GATWICK AIRPORT NORTHERN RUNWAY PROJECT

ISSUE SPECIFIC HEARING 9 | RESPONSE TO ACTION 7 (RESUBMISSION OF APPENDIX 1)

RESPONSE TO ACTION 7 ISSUE SPECIFIC HEARING 9 (RESUBMISSION OF APPENDIX 1)

Appendix 1

Figure 1: Daytime 51 dB LAeq,16h Noise Contour Areas

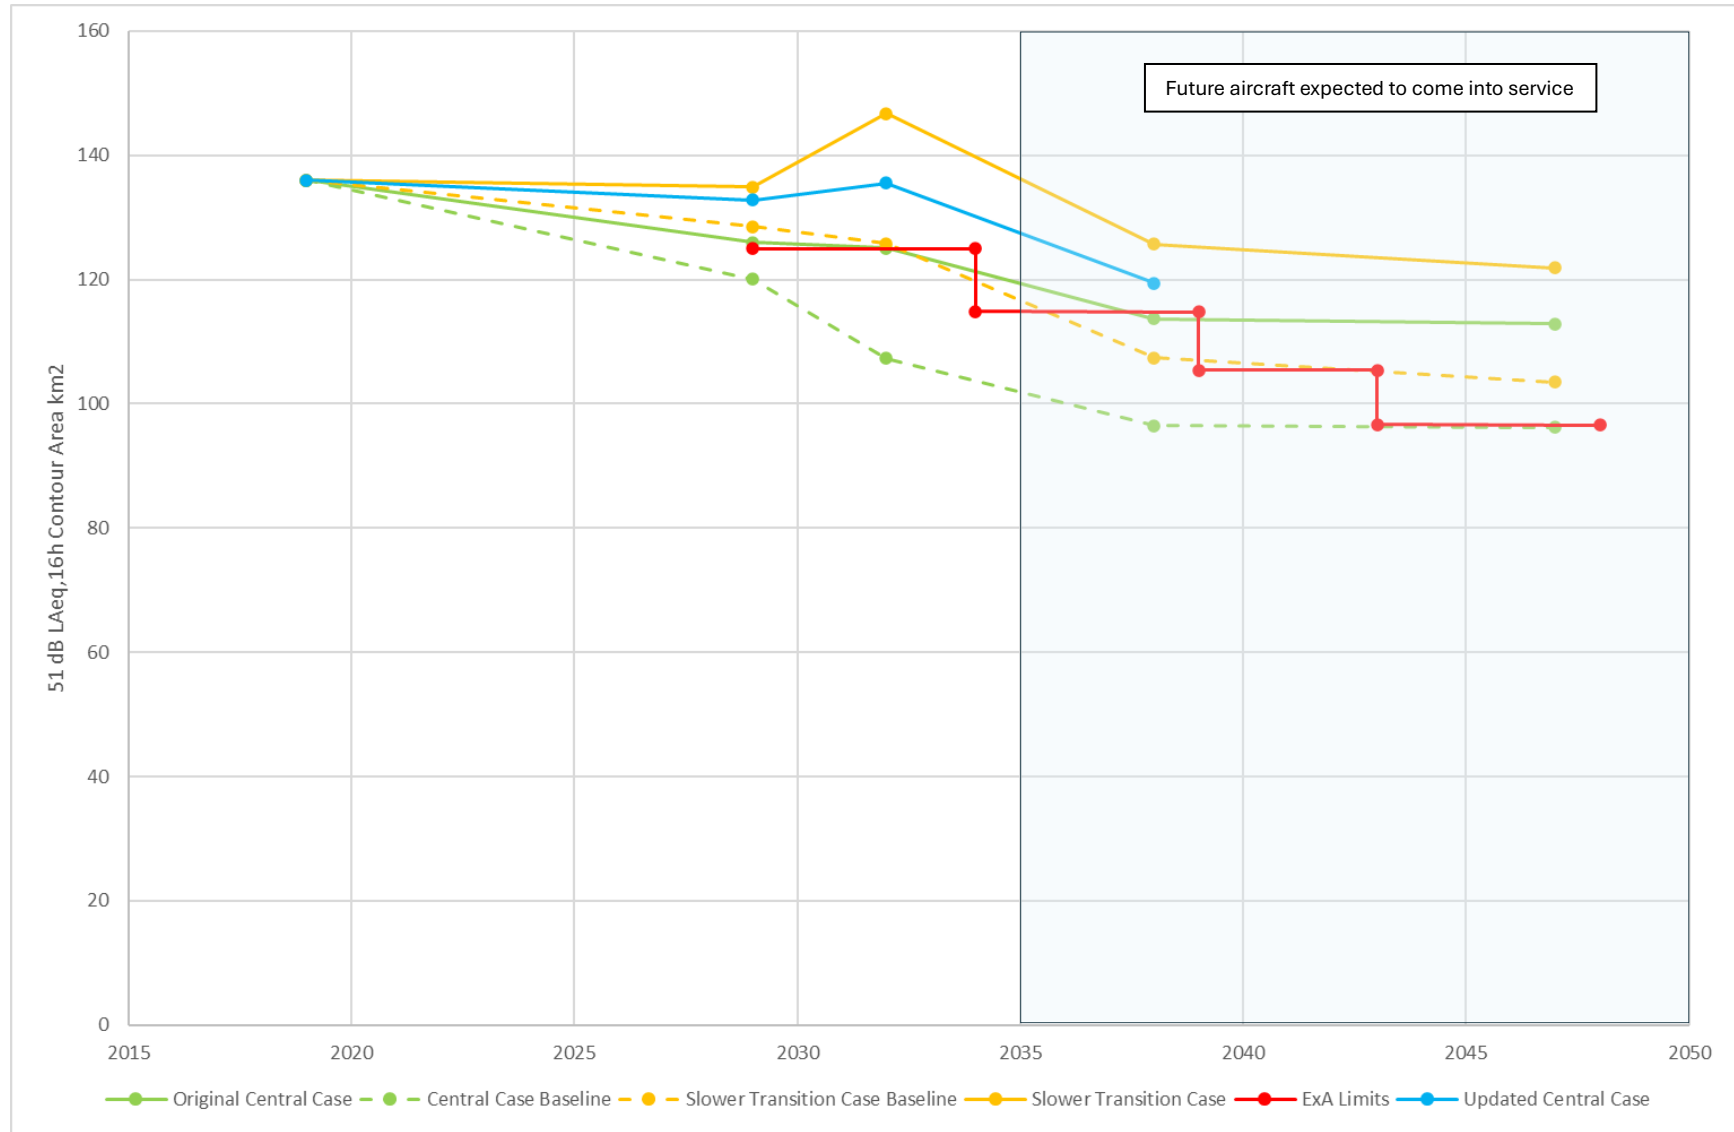
13. Figure 1 for the daytime 51dB $L_{Aeq,16h}$ noise contours:

- the Central Case baseline would be below the ExA's proposed noise limits until they converge in 2038.
- The Central Case with project broadly follows the ExA's noise limits, but it would be challenging to meet the noise limits after they drop in 2034 unless account is taken of ICAO's expectation for ongoing noise reductions with further new aircraft types is met.
- Both baseline and with project slow transition case fleet are above the noise limits at all times so would not be workable in terms of their fleet transition rates.
- The updated Central Case with project is above the noise limits at all times so would not be workable in terms of their fleet transition rates.
